Overview

The purpose of this notification is to communicate a change in the wafer fabrication and sort facility for all devices in the Platform Flash (XCF) and XC18V00 families of flash memory configuration PROMs devices. This notification does not apply to the Platform Flash XL (XCF128X) device. Note that this notification applies to Commercial (C) temperature grade products only. There is no change to the fit or function of these devices. The form of these devices is changing with topside marking changes only.

Production of all Platform Flash and XC18V00 families with the STMicroelectronics "T7Y" 150nm manufacturing process will transition from the STMicroelectronics M5 wafer fabrication facility in Catania, Italy to the Numonyx Fab2 wafer fabrication facility in Singapore (Table 1).

Figure 1: Sample Marking for Fabrication Change for XCF01S Device in VO20 Package

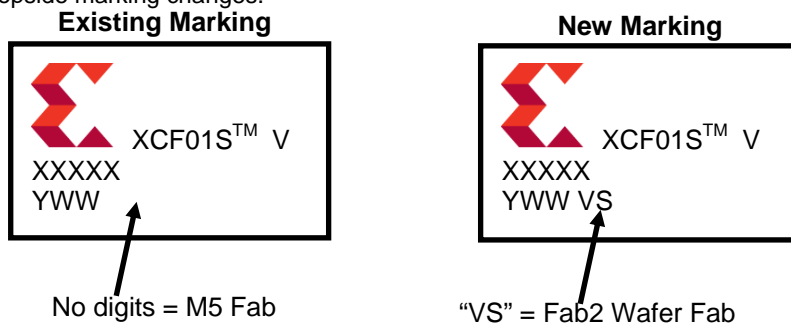
The topside marking will be changed from 'RT' to 'TT' for the FS48 and VO48 packages. For smaller package VO20 without process code on the top mark, the suffix "VS" will be added to the new marking for the VO20 package. Please refer to Figure 1 and 2 below for an illustration of topside marking changes.

Figure 3: **Sample Marking for Fabrication Change for XC18V01 Device in PC20 Package**

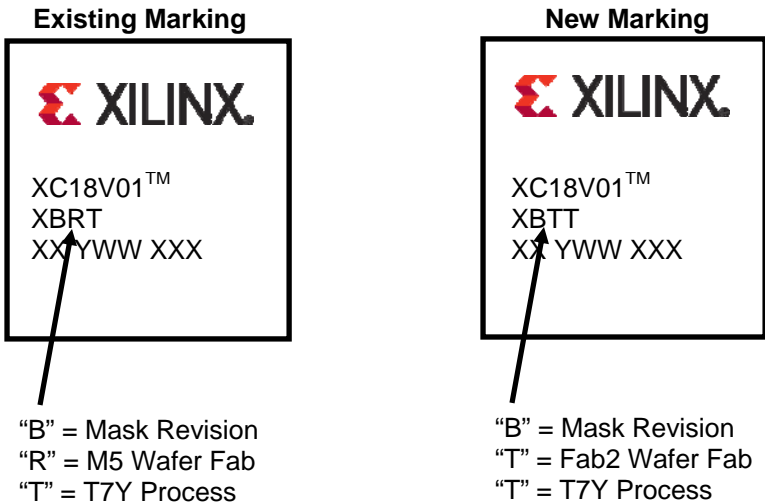
The topside marking will be changed from 'BRT' to 'BTT' for all the packages. An example for XC18V01 PC20 package is shown in Figure 3 below.
